Subject: Comments on Recently Received Documents Pertaining to  
Seattle Tacoma International Airport Project  
Third Runway – Low Flow Analysis

GeoSyntec Consultants (GeoSyntec) has been retained on behalf of the Airport Communities Coalition (ACC) to provide a technical review of investigation, analysis and design relating to geotechnical and hydrogeological elements of the proposed Third Runway Expansion Project at the Seattle Tacoma International Airport. GeoSyntec has previously commented on seismic and geotechnical aspects of the embankment fill and Mechanically Stabilized Earth Wall. In my October 2001 declaration in support of ACC's motion for stay, I raised numerous concerns relating to the Port's Low Flow Analysis. This letter presents an expansion on the issues raised in the declaration based largely on review of the November 27, 2001 report by Pacific Groundwater Group (PGG) titled "Port of Seattle - Sea-Tac Third Runway - Embankment Fill Modeling in Support of Low Streamflow Analysis."

Figure 1 - SeaTac Embankment Fill Grain Size Analysis

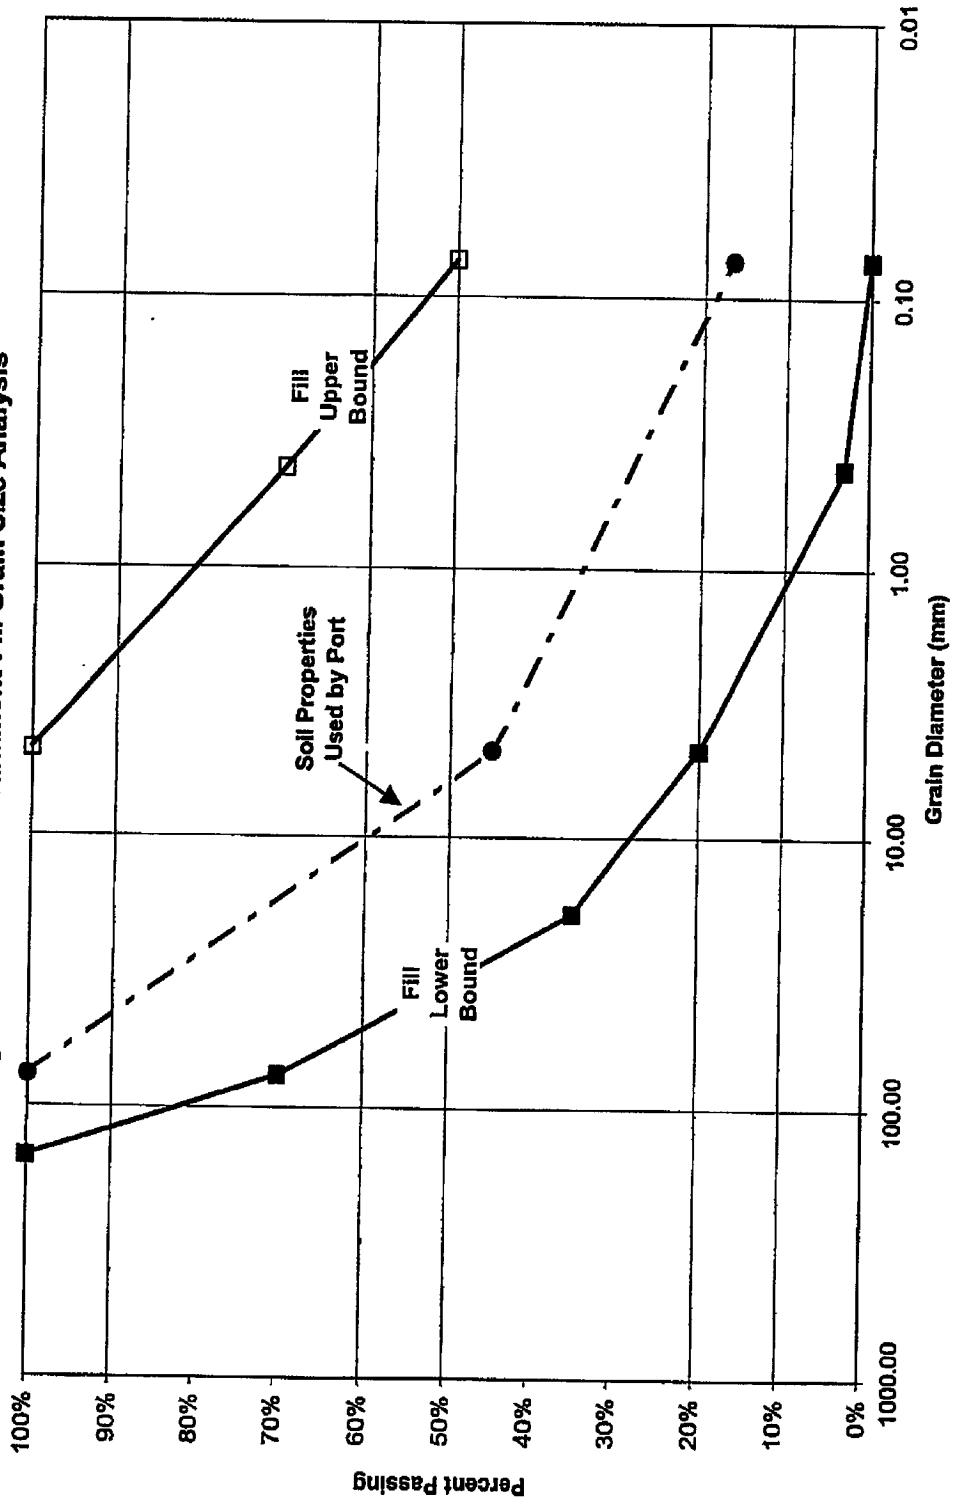
**Comment 2:** The analysis relies on a single set of soil parameters to represent the behavior of 20 million cubic yards of fill that will be obtained from numerous different borrow sources. This is a gross oversimplification and will lead to significant discrepancies between the predicted streamflows and those that would actually occur after construction.

The attached Figure 1 presents the range of soil grain sizes allowed by the project specifications and presents the single grain size representation used in the low flow analyses. Fill placement during construction of the embankment will occur in horizontal layers. As a result, there will likely be large areas of fill with fine-grained, low hydraulic conductivity material which will control the rate at which water flows vertically through the embankment. The overall hydraulic conductivity of the actual soil in the embankment could be several orders of magnitude less than that assumed for the current low flow analyses. This difference in hydraulic conductivity will have a substantial effect on the predictions made in the current analyses.

The current low flow analyses should not be accepted without a proper parametric evaluation of the influence of soil parameters on flow paths and travel times. A comparison of the soil parameters used for the low flow analyses and the range of soil types allowed for construction indicate that the flow rates through the embankment will be significantly more variable than the current analyses would indicate. That variability will likely increase the vault storage volumes required to protect low flow conditions in the creeks.

Figure 2a: Van Genuchten Parameter Variability

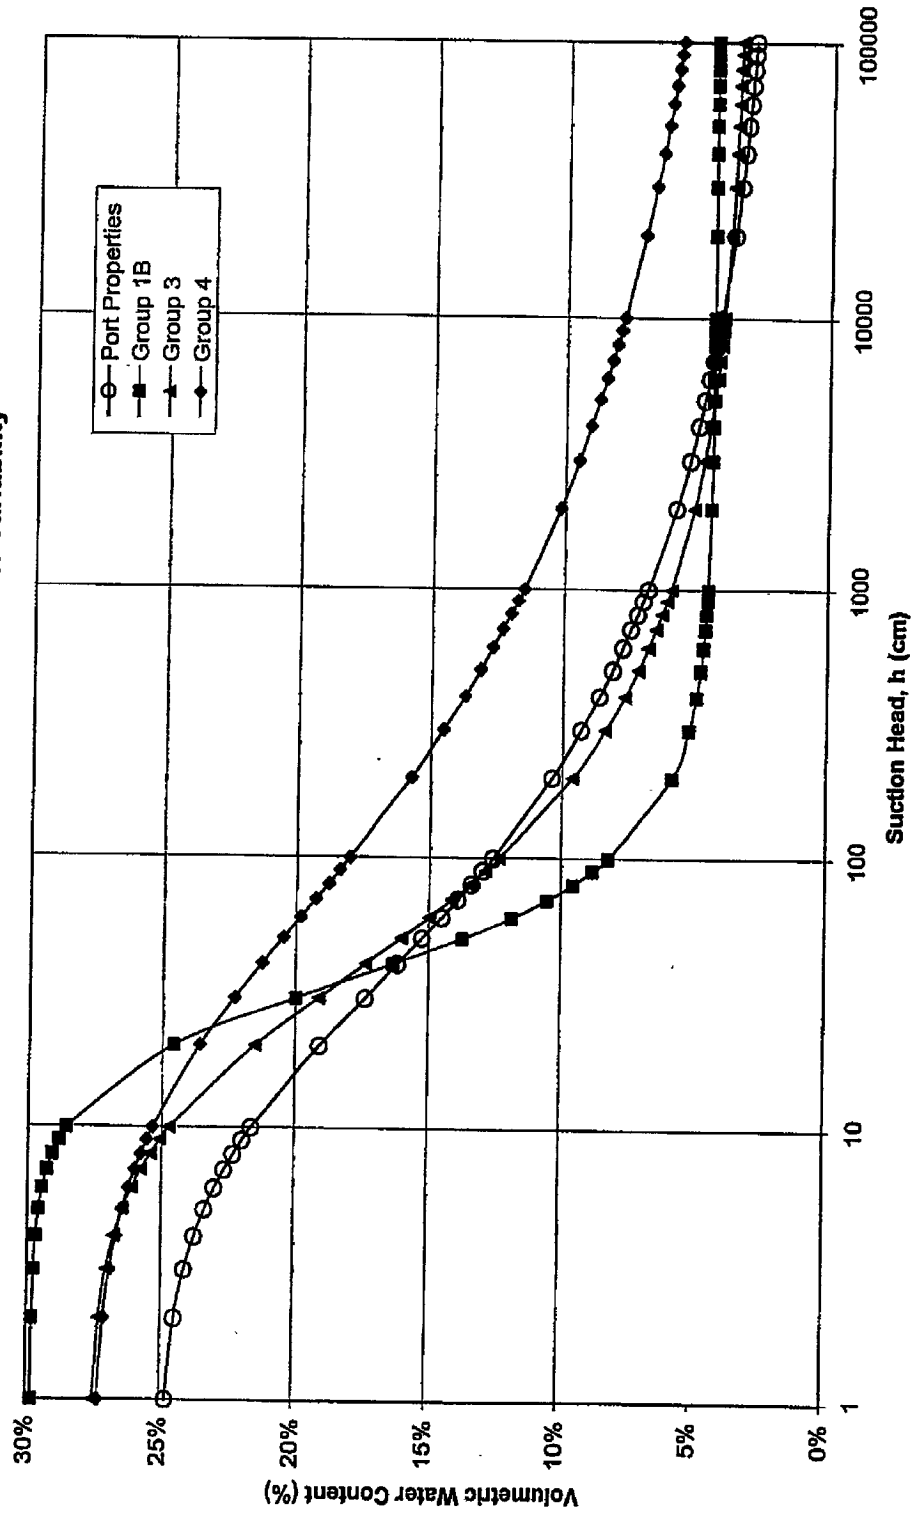
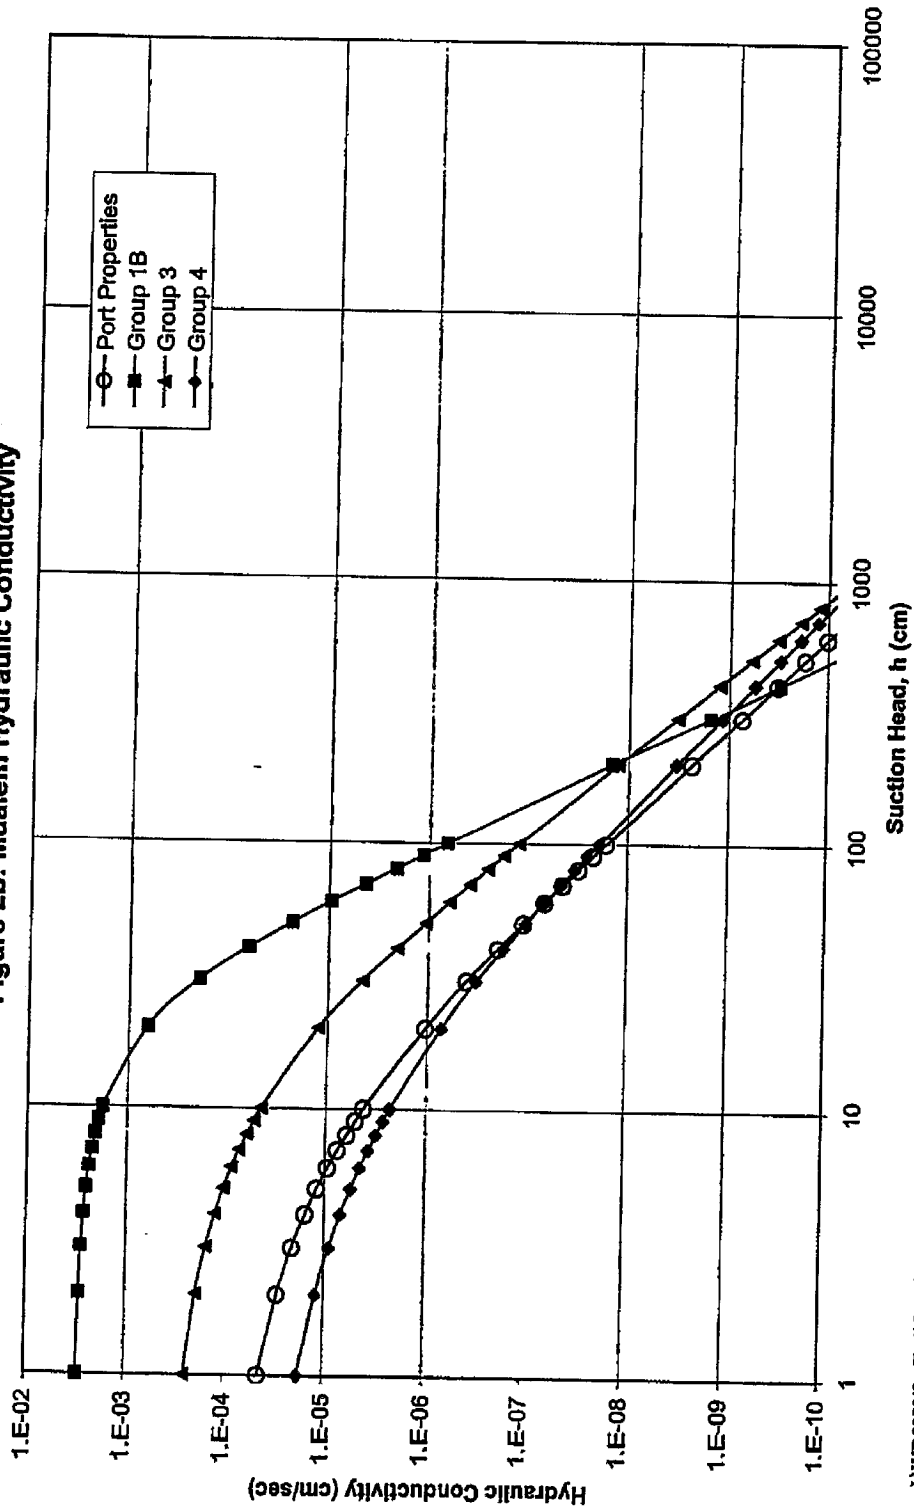
In Hart Crowser's "Embankment Infiltration and Seepage Studies" report<sup>2</sup>, they presented unsaturated flow parameters and corresponding unsaturated behavior curves for three of the fill types proposed for the embankment (Group 1B, Group 3, and Group 4). Figures 2a and 2b present the representative curves developed by Hart Crowser for the three fill types, along with the single set of curves being used presently by PGG in their Hydrus modeling (labeled "Port Properties"). While Hart Crowser's modeling with the HELP program was overly simplistic and their method of accounting for gravel content was not well validated, their performance of parametric studies on the fill types was a step in the right direction compared to the single fill type currently being modeled in Hydrus. The Hart Crowser properties show that the hydraulic conductivity (which controls the rate at which water will pass through the fill) can range over several orders of magnitude for soils likely to be placed in the embankment. The figures clearly show that the single curve being used by the Port is not representative of the potential range of behavior.

**Figure 3: 1-Dimensional Column Initial Lag Times for Infiltration to Reach Drainage Layer under Varying Soil Properties and Column Heights**

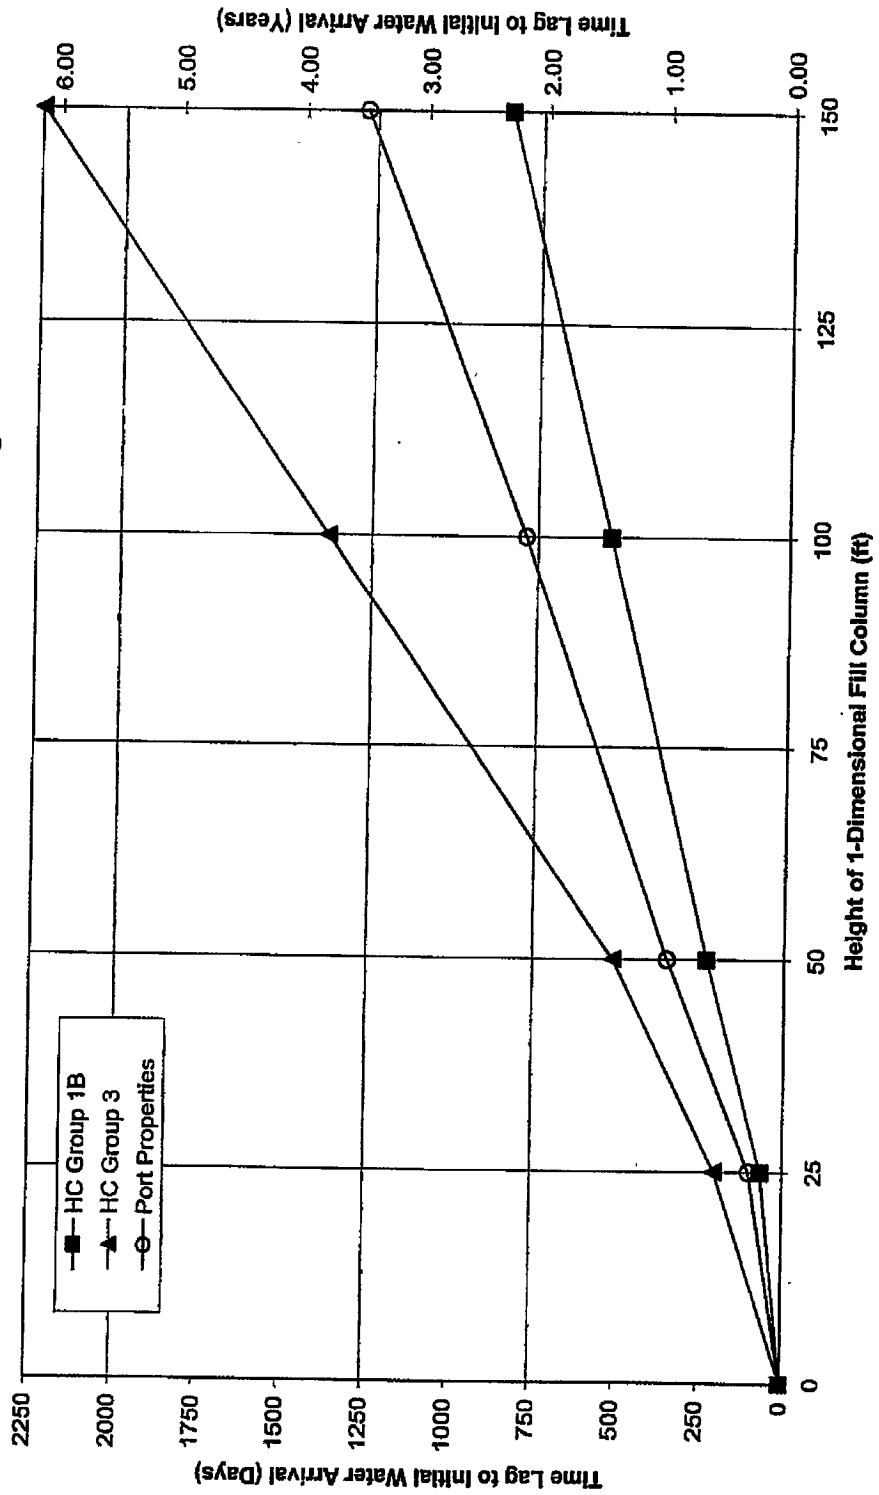
In order to demonstrate the influence of the variability of soil properties on the lag time between embankment construction and first arrival of water at the drain, several simple cases were analyzed. 1-Dimensional columns of varying fill thickness (25 ft, 50 ft, 100 ft, and 150 ft) were modeled using Hydrus for three different sets of fill properties (Hart Crowser Group 1B, Hart Crowser Group 3, and the Port Properties). The 1-Dimensional columns were modeled in a fashion similar to the Port's analyses, where all infiltration was assumed to travel vertically through the fill, without an allowance for horizontal flow. Figure 3 shows the results of these analyses. A curve is shown for each set of properties, immediately revealing the potential for variability in the results. Each point on the curves represents the time between the beginning of the analysis (Day 0) when the precipitation record begins, and the time when the first water reaches the drain at the base of the column. As the height of the 1-Dimensional column is increased (i.e. as the embankment fill thickness increases) the time lag increases relative to the properties for each fill type. For example, for a 50 ft fill thickness, the range of time lags shown is 250 to 500 days (approximately 0.7 to 1.4 years), and for a 150 ft fill thickness, the range is 850 to 2250 days (approximately 2.3 to 6.2 years). It will be shown later that ignoring the horizontal flow component in the fill (i.e. performing a 1-Dimensional analysis) results in an overestimation of the rate at which water flows through the fill, and thus the predicted lag times will actually be even longer than these values. In any case, the differences clearly demonstrate the potential variability in results which the port is ignoring in their analyses. Incorporation of this type of

parametric study in the Port's analysis will likely have a significant impact on the design of the Port's low flow mitigation scheme and is absolutely necessary for proper representation of the possible impacts of the embankment fill.

Figure 4a: Current Model System, all flow travels vertically through sand & silt matrix

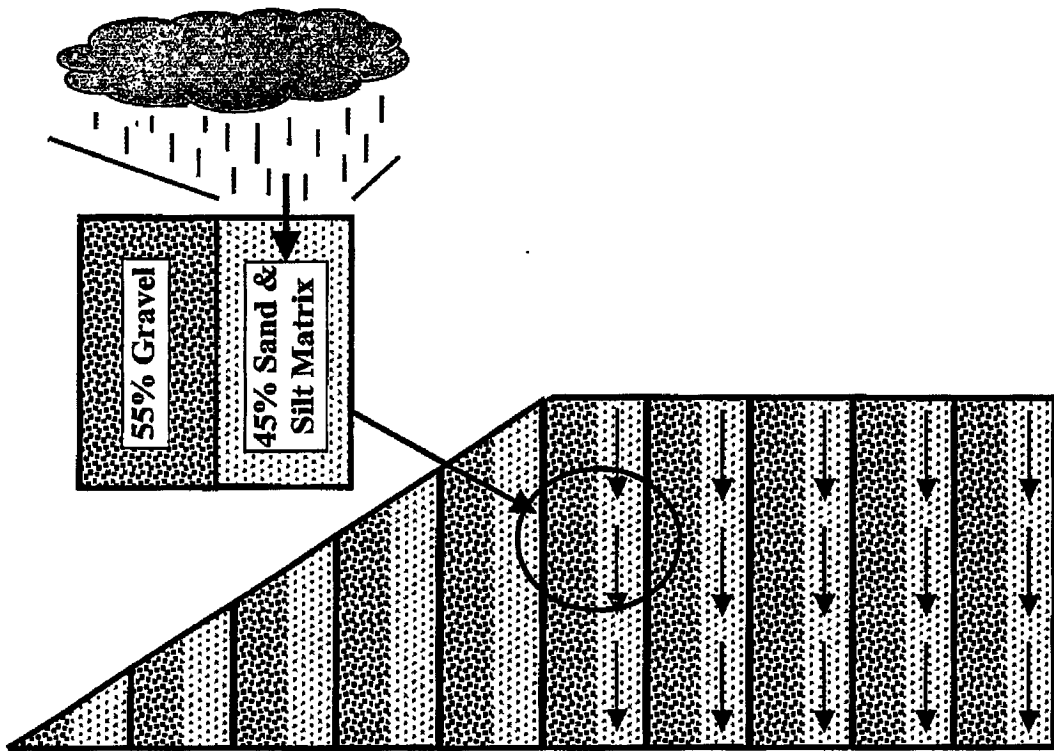
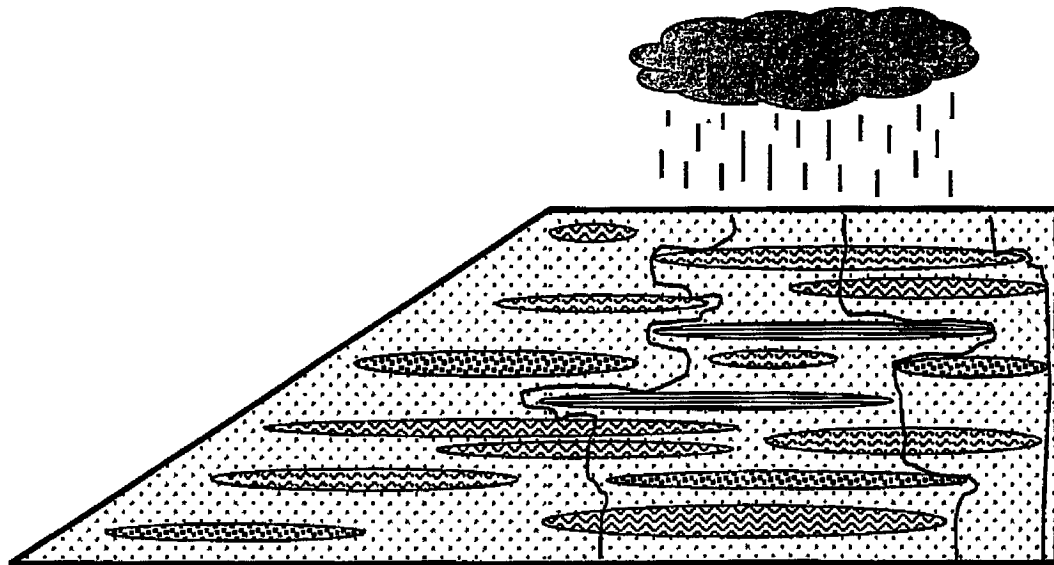
Comment 4: The Port's method of modeling of flow through the fill as a 1-Dimensional phenomenon using Hydrus is an oversimplification of a truly 3-Dimensional process, and will result in an overprediction of the rate at which water travels through the embankment.

In addition to the Port's ignoring the gravel content of the embankment fill, their analysis consists of a series of 1-Dimensional columns of soil of varying thickness which force the infiltrating water to travel downward unimpeded without any lateral migration. Figure 4a shows a schematic of the system the port is actually modeling. Each column theoretically consists of 55% gravel and 45% sand and silt. However, water falling on any given column of soil is forced through the sand and silt matrix (achieved through artificial adjustment of precipitation and discharge quantities), bypassing the gravel completely. It should also be noted that water falling on the sloping face of the embankment is assumed not to infiltrate at all, and because the water can only travel vertically, this region never sees any water at all.

Figure 4b shows a schematic (which is still a simplification) of the type of layering that will exist in the embankment fill as a result of the construction process. 20,000,000 cubic yards of fill will be imported from numerous borrow sources and placed in horizontal layers at the then current elevation. The soil layers with the lowest hydraulic conductivity will control the vertical rate of flow of water traveling through the embankment. It will be impossible for the Port to control the fill sufficiently that an assumption of uniform flow behavior can be assumed realistically. The Port has failed to consider the very real variability of the soils that will be placed in the embankment. As a result of the fill layering, the flow path will be significantly more complex than

represented by the Port (e.g. Figure 4a), and the time for water to travel through the embankment will be much slower than predicted.

Figure 5: Moisture Content Variation Over Time for Cross Section 2  
 Using Hart Crowser Group 3 Embankment Fill Properties  
 F:\WR0380(SeaTac)\Submittal\GeoSyntec SeaTac Comment Letter #3.doc

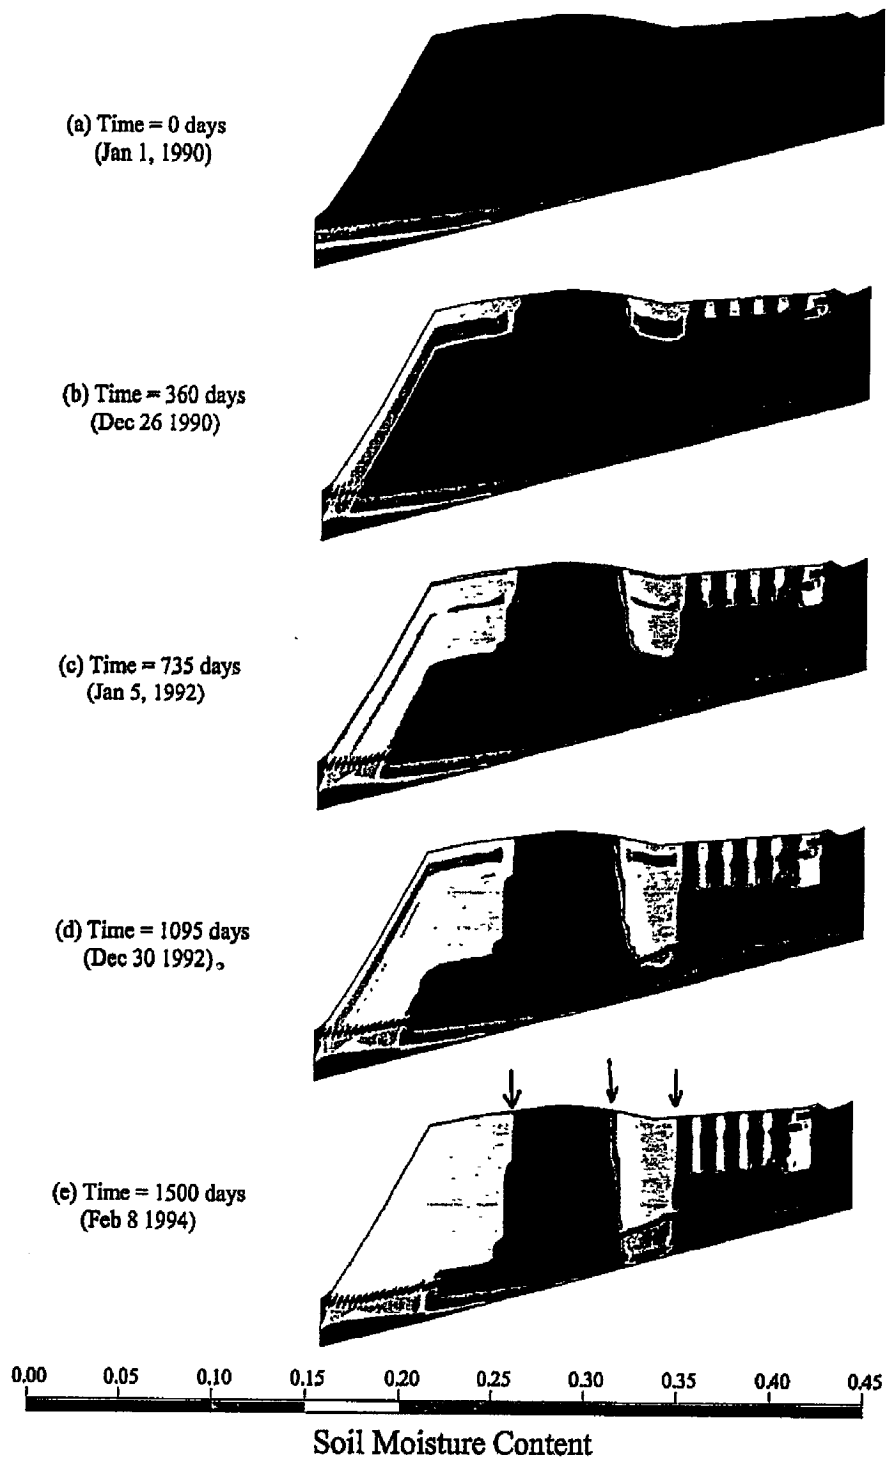
Figure 5a presents a schematic of the Hydrus model cross-section being used by GeoSyntec, which is based on PGG's section 2, with an embankment fill height of up to 110 ft. The embankment fill, the drainage layer, the outwash layer, and the underlying till are all being modeled within Hydrus. The model is being run using approximately four years of daily precipitation data (January 1990 through February 1995) from the SeaTac airport. No runoff or evapotranspiration calculation has been made, so all precipitation is assumed to enter the embankment.

Figures 5a through 5e present preliminary results using the Hart Crowser Group 3 fill properties described in Comment 2. The lighter colored front that progresses downward over time represents the propagation of the infiltrating precipitation. It is clear that the water infiltrating near the face of the slope, which has a shorter travel path to the drainage layer has already begun to reach the drain and then the creek by approximately 1 year after the modeling begins (Figure 5b). However, the flow under the thick majority of the embankment is only beginning to reach the drainage layer between 3 and 4 years (Figures

5d and 5e). With the uniform soil profile assumption relied upon by the Port, there is only slight evidence of horizontal flow of water, although Figures 5b through 5e show a gradual narrowing of the dark colored band of dry soil beneath the runway, indicating that moisture is gradually working its way laterally. This effect can also be seen in the flow of water between the filter strips on the right side of the model. The significance of this lateral flow component is that water will travel within the embankment fill for longer periods of time prior to reaching the drain and the creeks than with analyses limited to vertical flow only. The Port, using their simplified analyses, has reported none of these trends.
